COOPER NUCLEAR STATION

AMENDMENT TO FACILITY OPERATING LICENSE

Amendment No. 62
License No. DPR-46

ATTACHMENT TO LICENSE AMENDMENT NO. 62

Figure B 1 2
Cooper Nuclear Station
Organization Chart

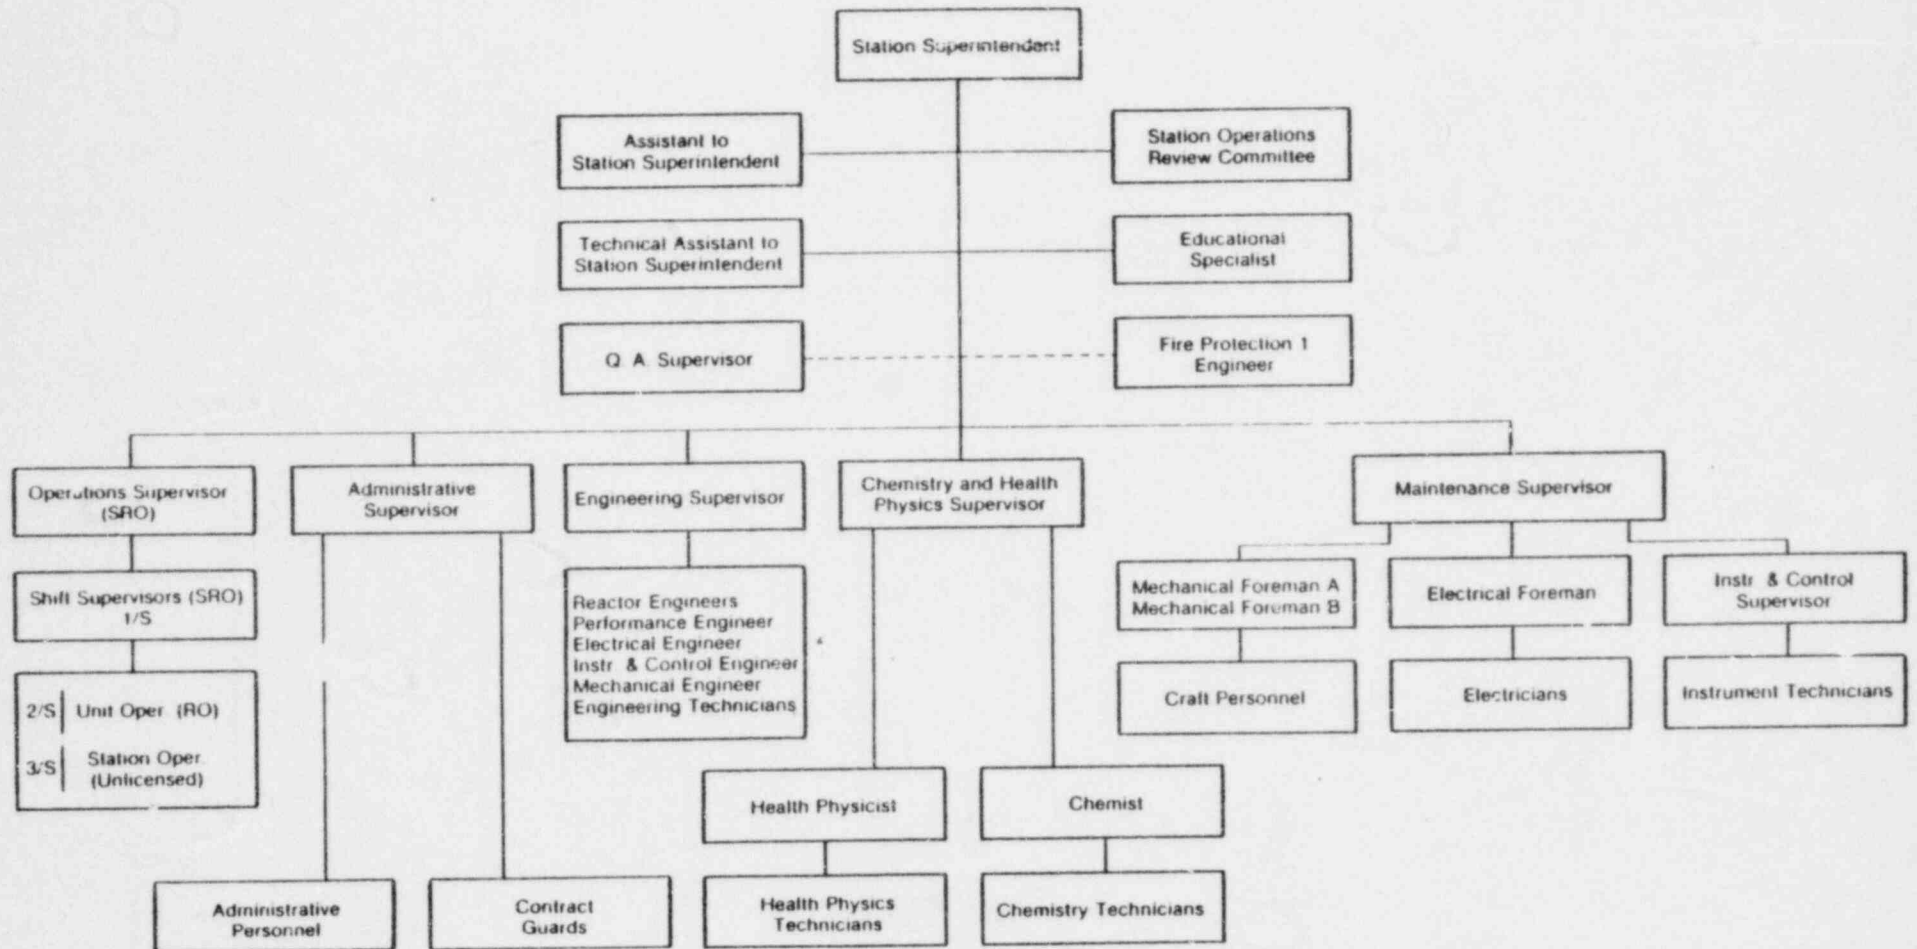
6.1.3 The organization for conduct of operation of the station is shown in Fig. 6.1.2. The shift complement at the station shall at all times meet the following requirements. Note: Higher grade licensed operators may take the place of lower grade licensed or unlicensed operators.
